F.0 FINAL ENVIRONMENTAL IMPACT REPORT

In accordance with the above-listed requirements, this FEIR for the proposed Roquet Ranch project (hereafter, the “Project”) and associated discretionary and administrative actions consists of the following:

DRAFT ENVIRONMENTAL IMPACT REPORT (EIR) FOR ROQUET RANCH
SPECIFIC PLAN PROJECT (SCH# 2016061056)

FIGURE 1 – 1888 IRRIGATION MAP

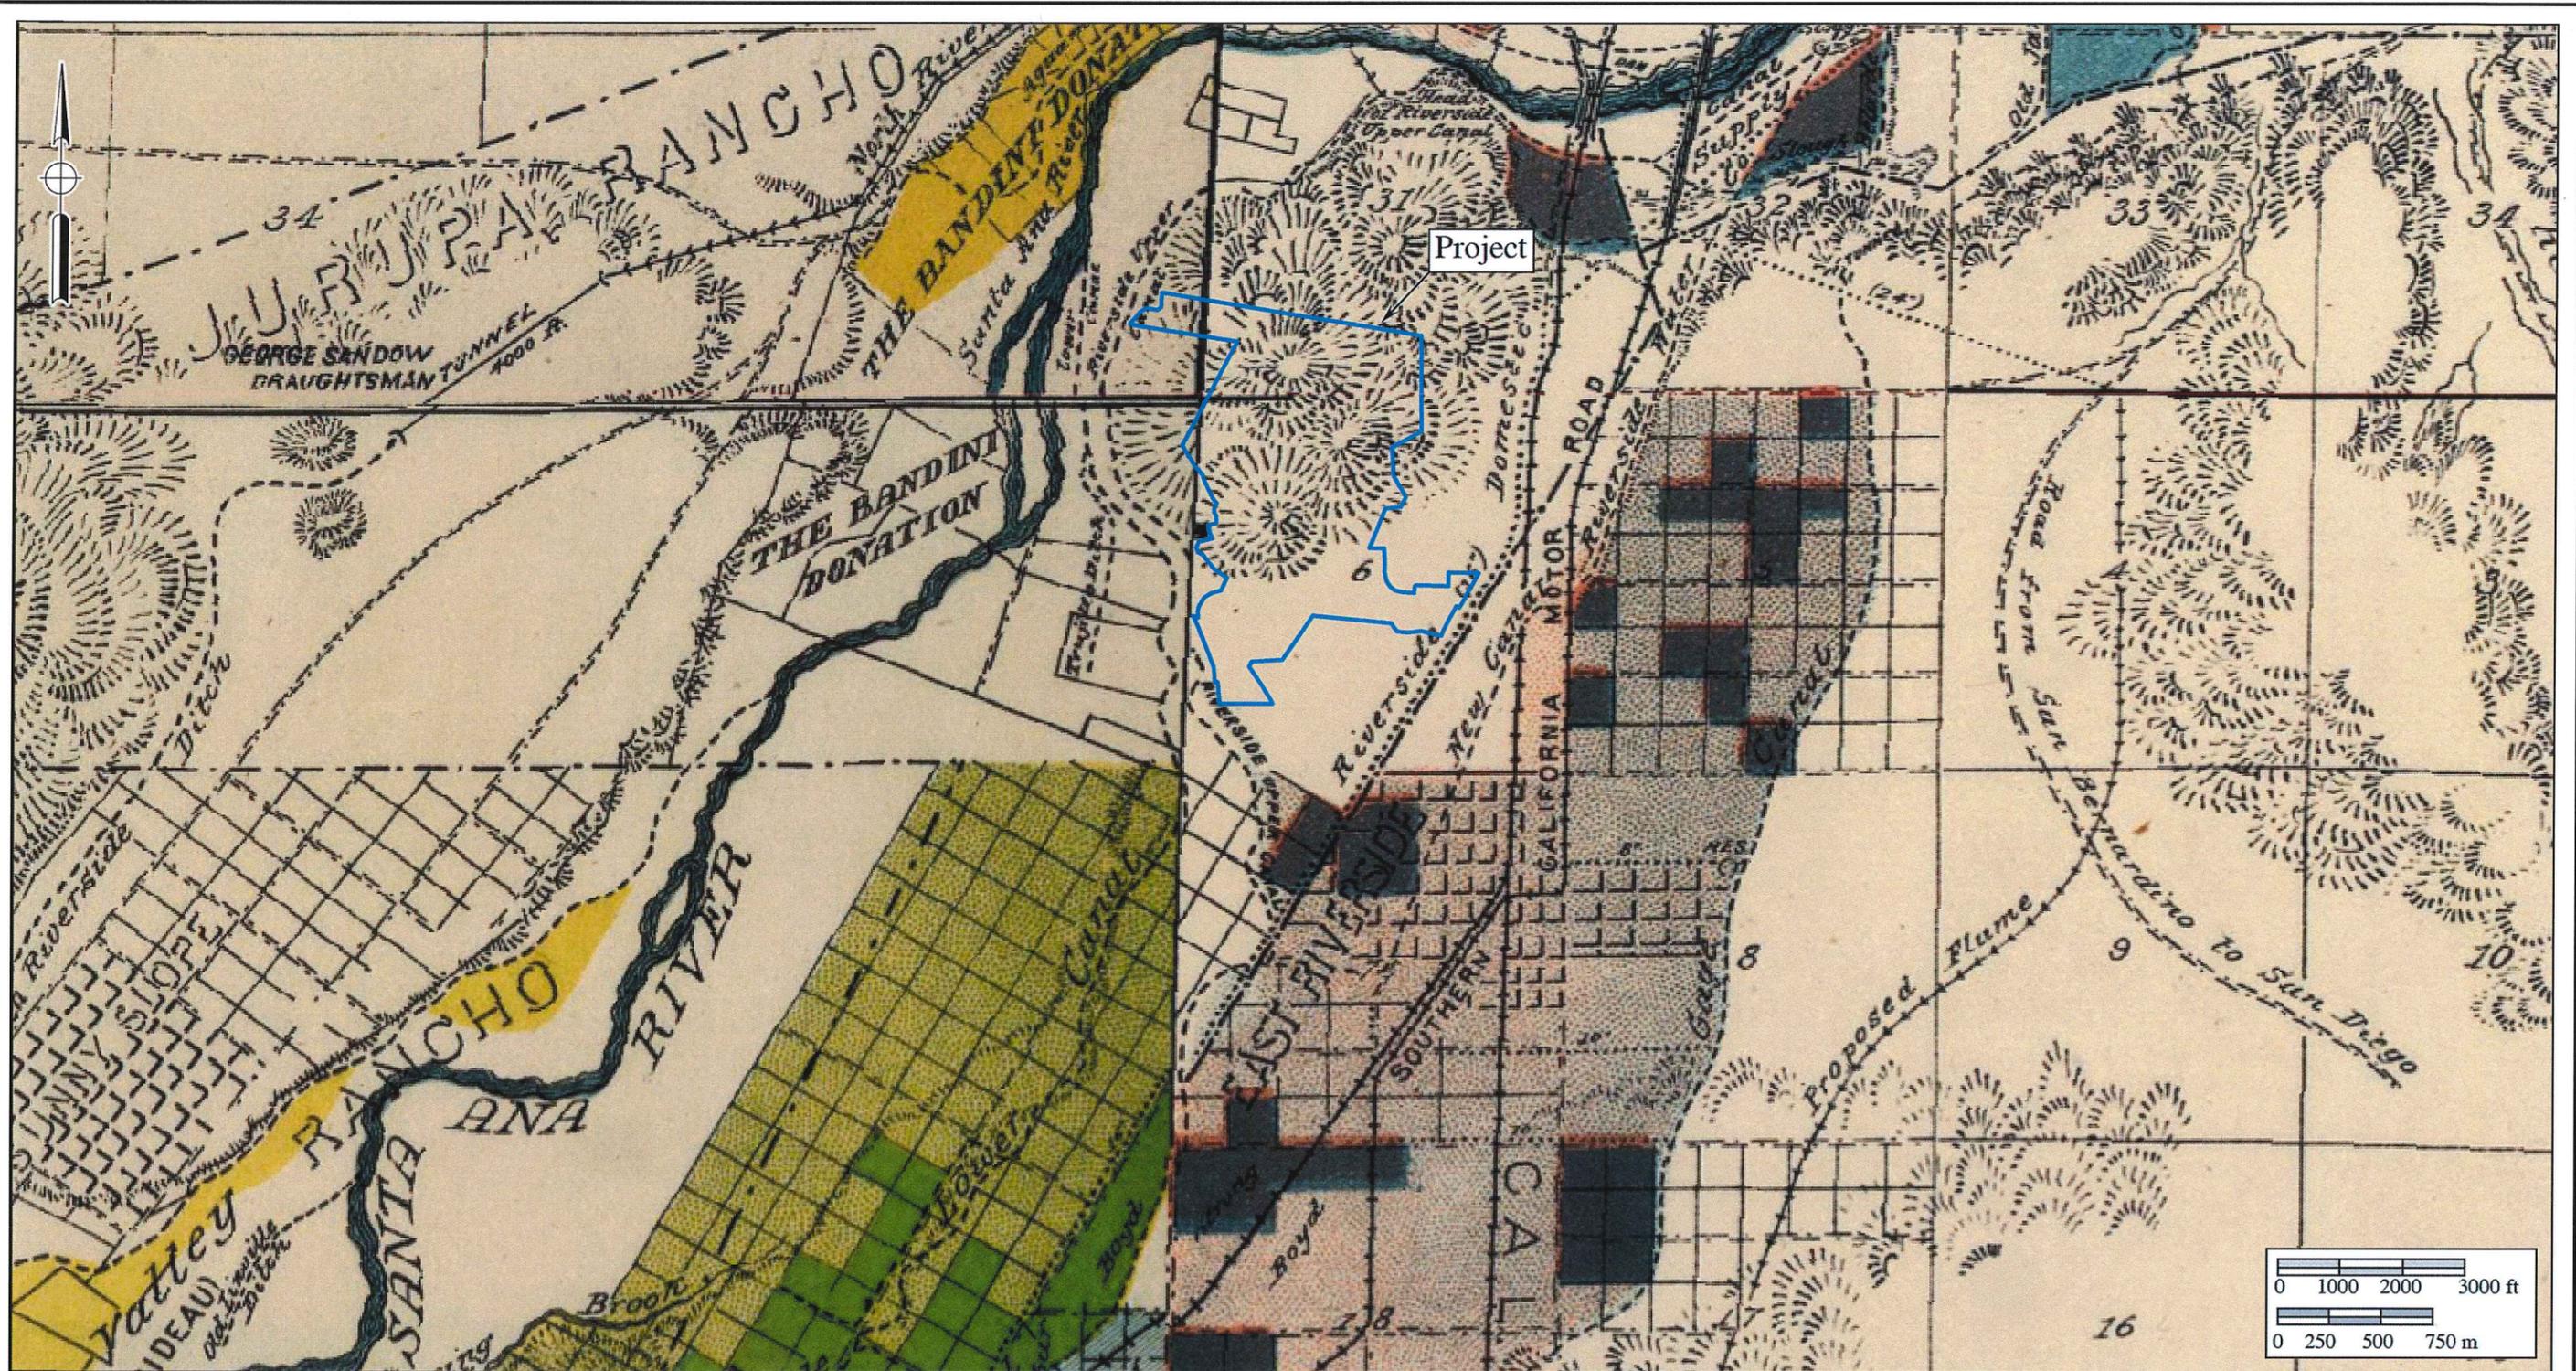
In 1875, the workers building the Riverside Lower Canal discovered that the Trujillo Ditch was located within the alignment they were trying to use. The owners of the Trujillo Ditch water claim allowed the new Riverside canal to take the place of theirs under the agreement that the Trujillos would take their water from the canal at a lower point to the southwest of the final alignment¹⁵. An 1888 irrigation map of the region (see Figure 1 prepared by Brian F. Smith and Associates which is included as Attachment C) shows the land that Bandini donated (labeled as "The Bandini Donation") and the alignments of the Trujillo Ditch, the Riverside Upper Canal, and the Riverside Lower Canal, all of which are located outside of the western Project site boundary.
